Appendix C: 10-, 50-, 100-, & 500-Year Hydrographs

Finalized Checklists

Checklist for Hydrologic Analysis

City of Carrollton
Denton County, Texas
Floodplain Update Study

Dudley Branch

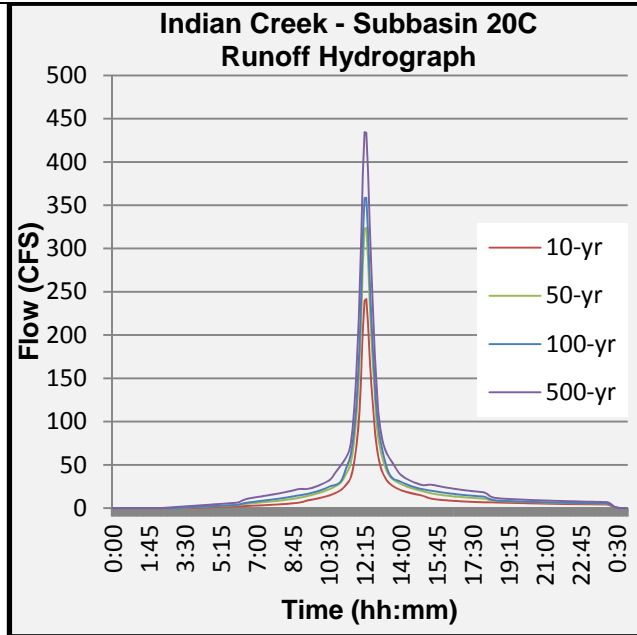
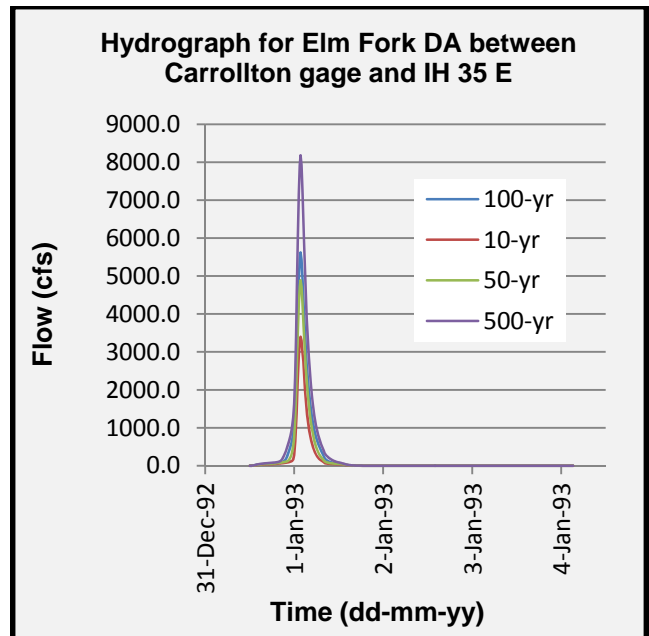
| Number | Sub Step | Sub Step Description | Reviewer Comments | Issues (Y/N) | |
|--------|--|--|--|---|---|
| | | j | Review hydrographs to ensure that simulation was run long enough to capture peak | Yes. The simulation was done at a 5 minute interval, and the peak was captured. | N |

1. 3 separate hydrographs were extracted, one for each branch (1) and one for each additional subbasin (2) along our stretch of river.

Indian Creek

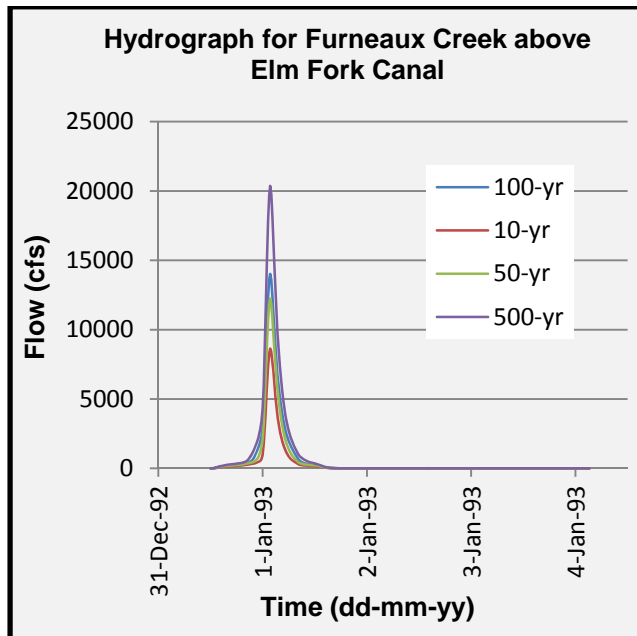
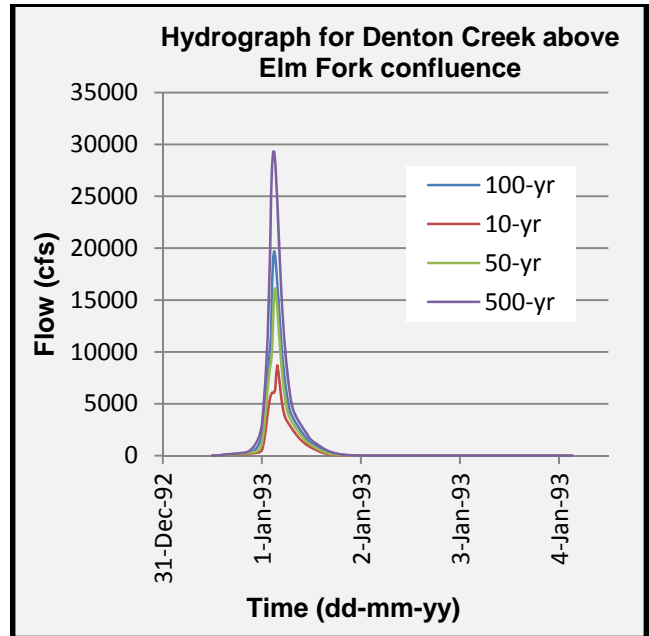
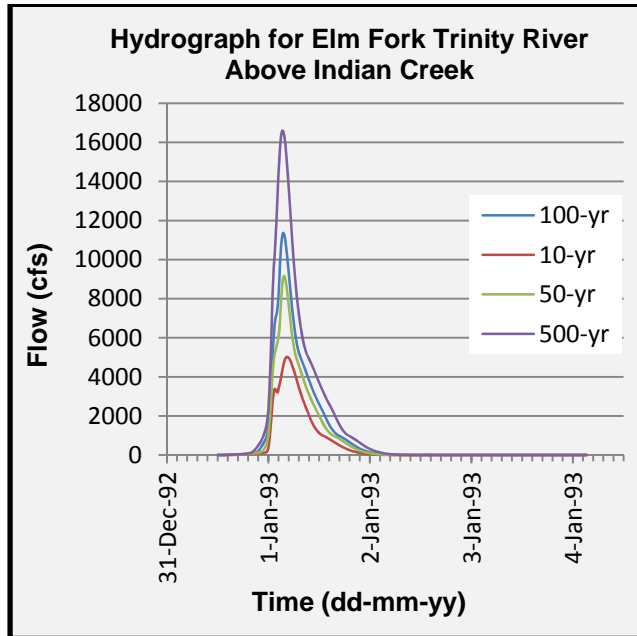
| Number | Sub Step | Sub Step Description | Reviewer Comments | Issues (Y/N) | |
|--------|--|--|--|---|---|
| | | j | Review hydrographs to ensure that simulation was run long enough to capture peak | Yes. The simulation was done at a 5 minute interval, and the peak was captured. | N |

1. 5 separate hydrographs were extracted, one for each branch (2) and one for each additional subbasin (3) along our stretch of river.

Elm Fork Trinity River

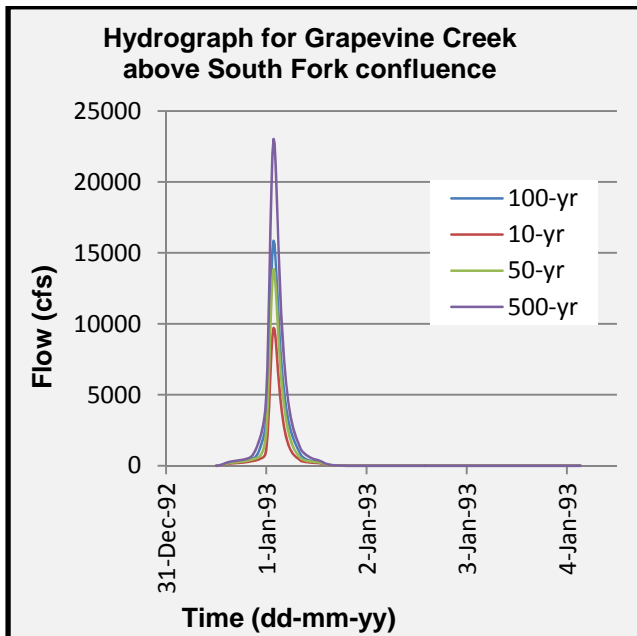
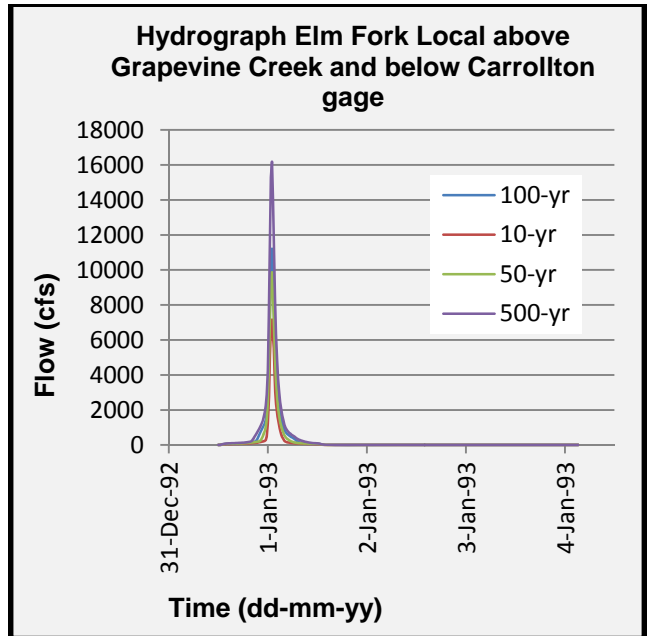
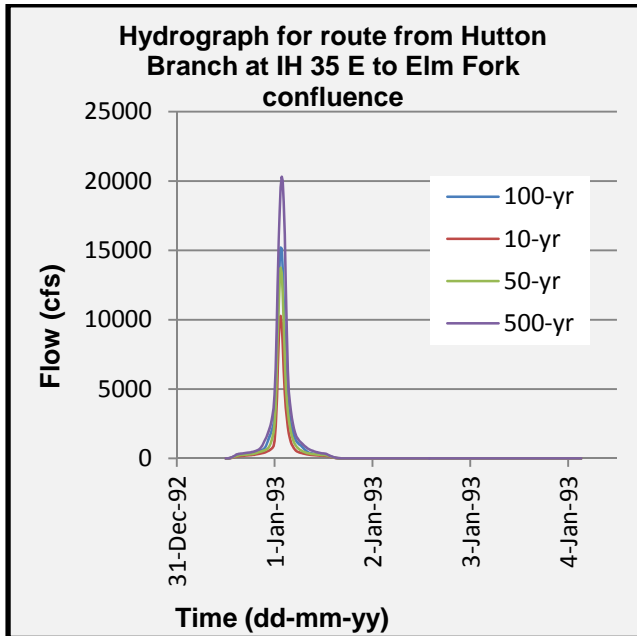
| Number | Sub Step | Sub Step Description | Reviewer Comments | Issues (Y/N) | |
|--------|------------------------------------|----------------------|--|---|---|
| | | j | Review hydrographs to ensure that simulation was run long enough to capture peak | Yes. The simulation was done at a 15 minute interval, and the peak was captured. | N |
| 7 | Present Results to Senior Engineer | a | Extract time-series data and present it to senior engineer | Time Series data extracted at 50 sqmi location. | N |

Timber Creek

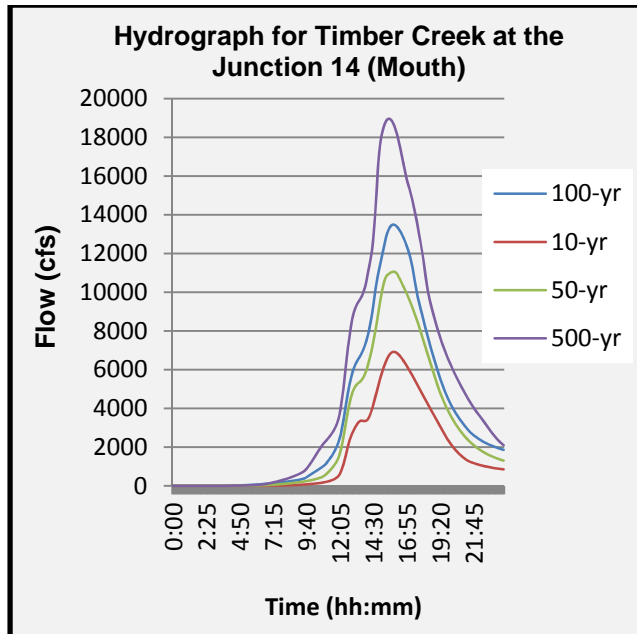
| Number | Sub Step | Sub Step Description | Reviewer Comments | Issues (Y/N) | |
|--------|------------------------------------|----------------------|--|---|---|
| | | j | Review hydrographs to ensure that simulation was run long enough to capture peak | Yes. The simulation was done at a 5 minute interval, and the peak was captured. | N |
